DEVELOPMENT APPLICATION

PDPLANPMTD-2023/038472

PROPOSAL: Dwelling

LOCATION: 14 Saltwater Rise, Seven Mile Beach

A.14
 RFI RESPONSE

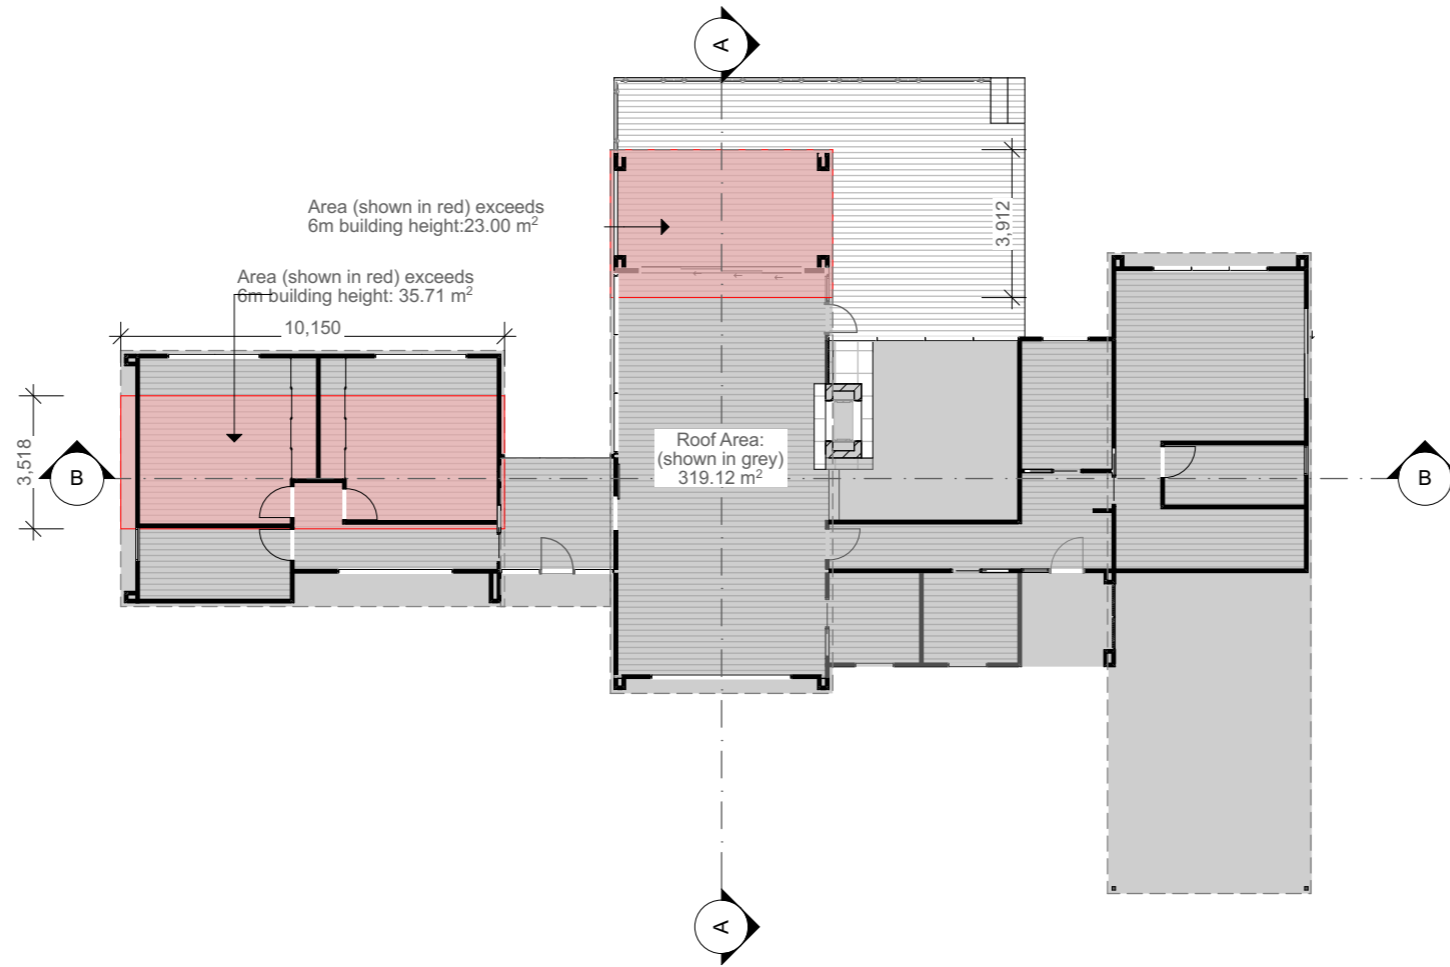
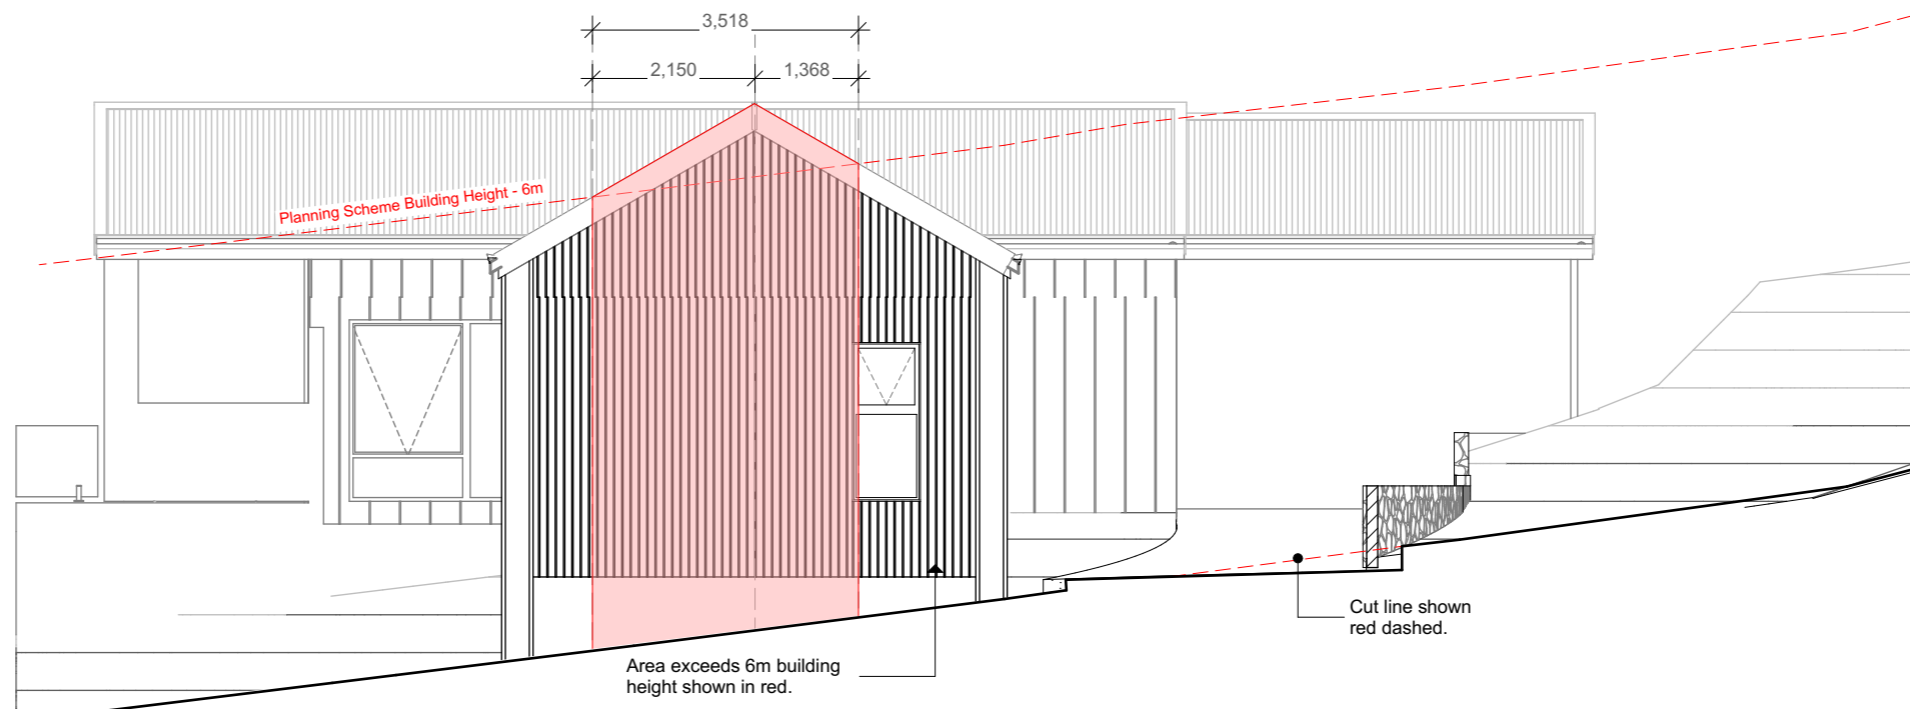
COUNCIL Planning RFI:

The Acceptable Solution A1 at Clause CLA-S3.7.2 of the Single Hill Specific Area Plan requires that building height must not be more than 6m. The elevations provided in the submission show a proposed building height of 7.575m for some parts of the dwelling. The proposal therefore does not comply with the Acceptable Solution and must be assessed against Performance Criterion P1 of the same Clause, which states that building height of up to 9m may be considered if it can be demonstrated that:

- (a) any part of a building in excess of 6m in height represents less than 20% of that building's site cover;
- (b) site conditions, such as slope, soils or the presence of vegetation to be retained make it unreasonable to comply with the acceptable solution; and
- (c) the combination of building siting, design, external materials and colours and landscaping will effectively minimise visual impact.

In order to assess your proposal against this criterion, we require:

- (a) an amended set of elevations annotated to indicate reduced levels (RLs) for the pad, the finished floor level, and the ridge levels; and
- (b) at minimum two sectional elevations cut (approximately) along the lines a-a and b-b indicated in the diagram below. In particular, this will assist us in determining the proposal against CLA-S3.7.2 P1(a).

Response:

The Floor Plan and North Elevation on Sheet A.14 and Section A & B on Sheet A.15 demonstrated any part of the proposed dwelling exceeding 6m building height constitutes 18.40% of the total dwelling's site cover/roof area.

Proposed dwelling's site cover/ roof area: 319.12m²
 Areas exceed 6m building height: 58.71m²
